COTTAGES AT HASTINGS GREEN

ROOF ASSESSMENT

PONO BUILDING CONSULTANTS

August 11, 2023

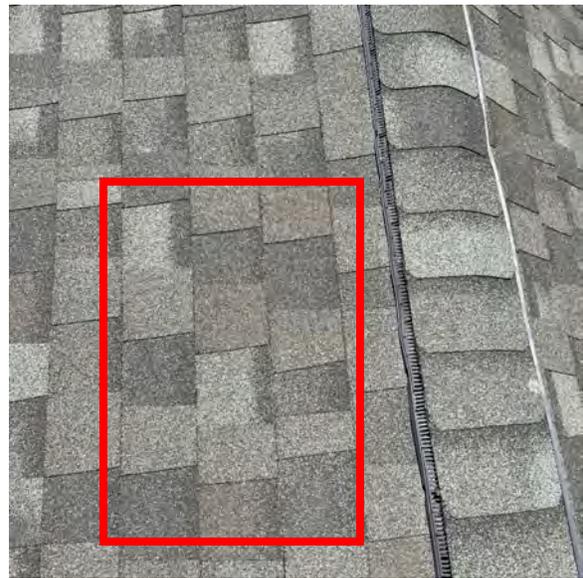
1A. Fasteners penetrate through sheathing at eave.
Location: Systemic throughout property

1B. Additional example of fasteners penetrating sheathing at eave.

1C. Additional example of fasteners penetrating sheathing at eave.

1D. Additional example of fasteners penetrating sheathing at eave.

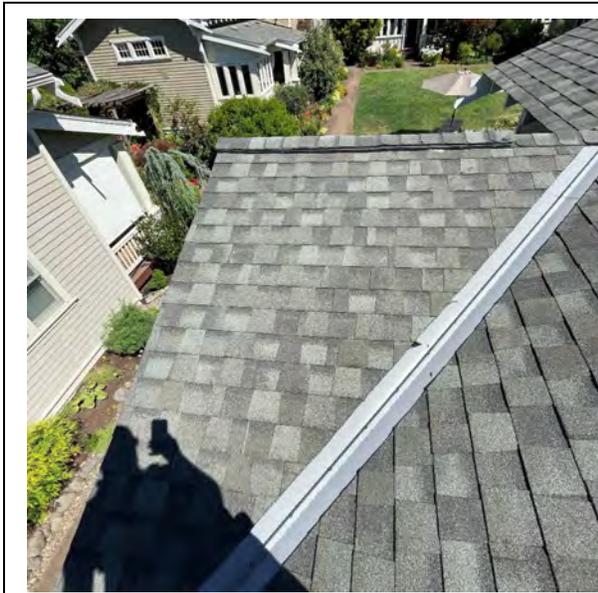
12. Metal valley does not sit flush against roof.

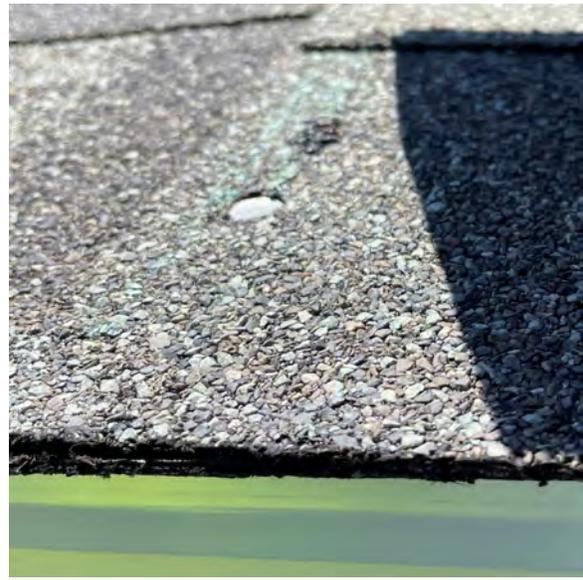
16. Starter strip fasteners omitted.
Location: 7021, 7071

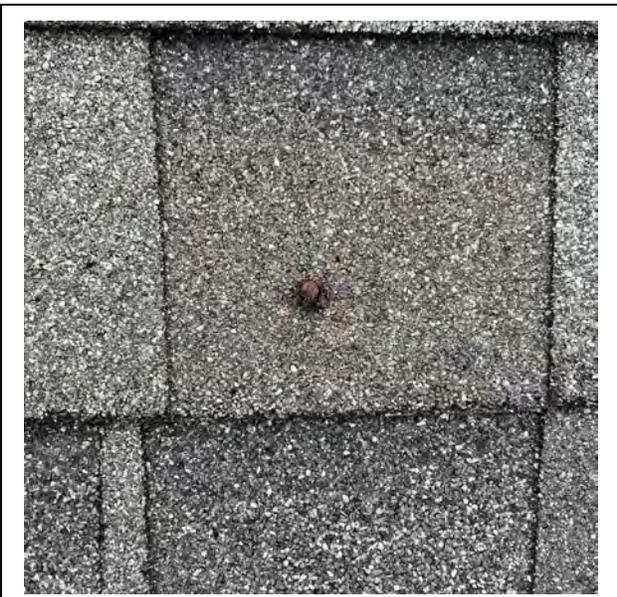
20B. Additional example of overdriven nails.

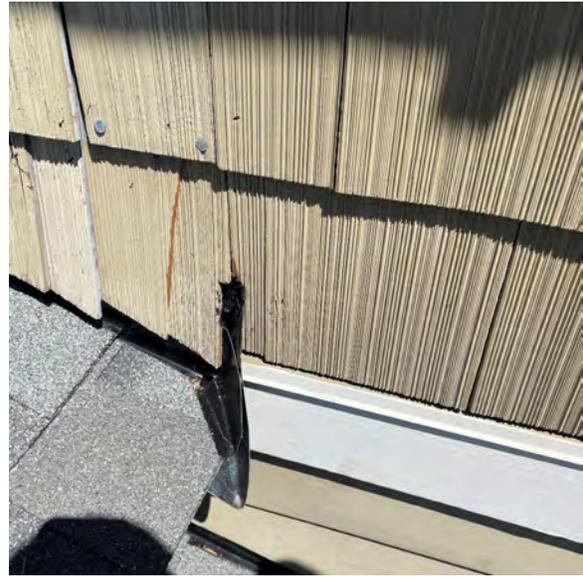
36A. Diverter flashing at drip and rake edge omitted.
Location: 7022, 7046, 7067, G1-5, G20-23

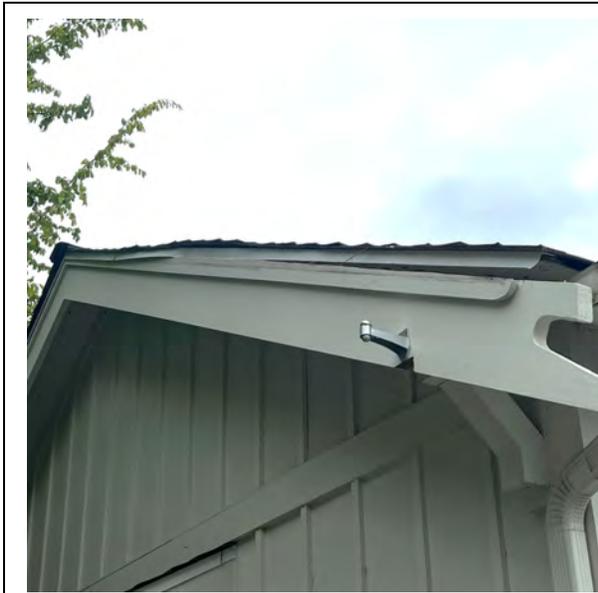
51. Ice and water shield omitted at RVO vent.
Location: 7025, 7029, 7033, 7039

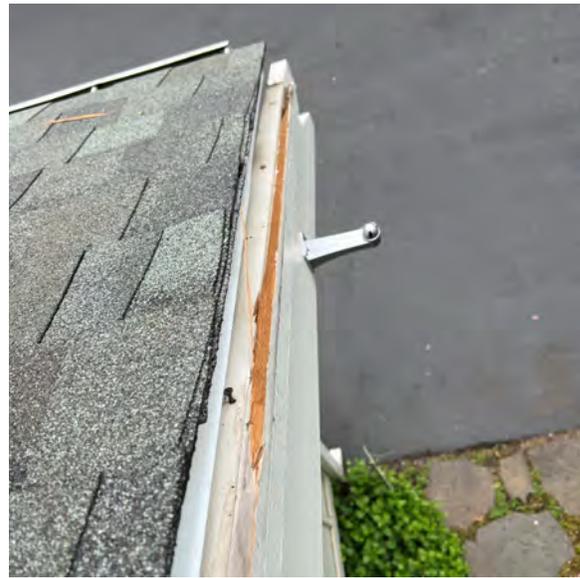
54. Chimney cap fastener is missing.
Location: 7071

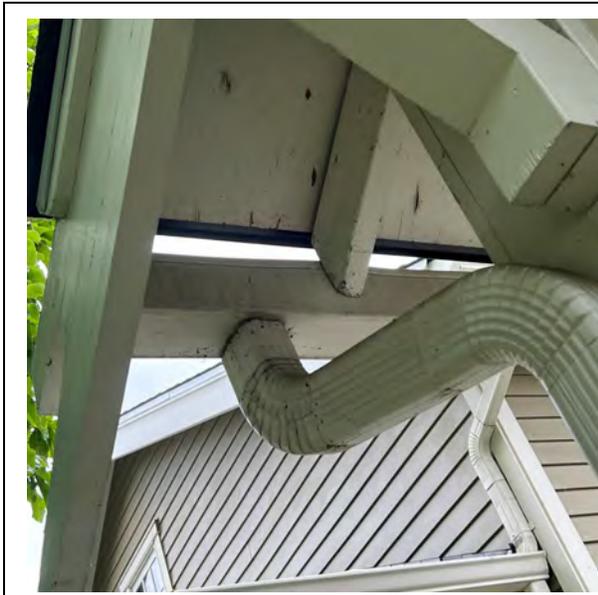
59B. Additional example of inadequate space between gutter end cap and barge board.

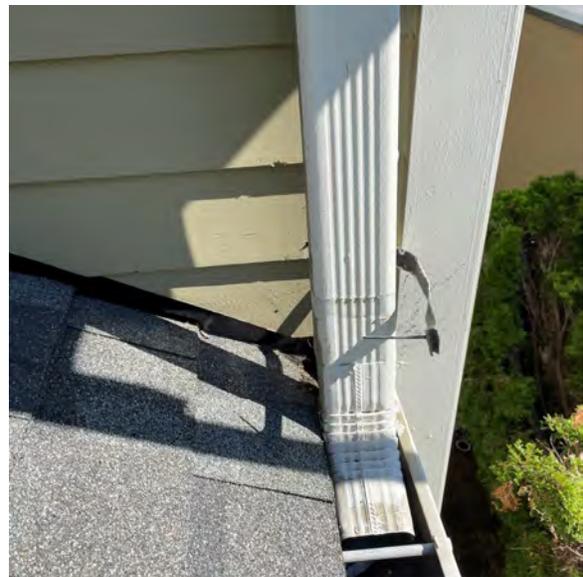
66. Downspout is clogged with debris. Downspouts should be cleaned on a regular schedule to prevent debris build-up.
Location: G6-10
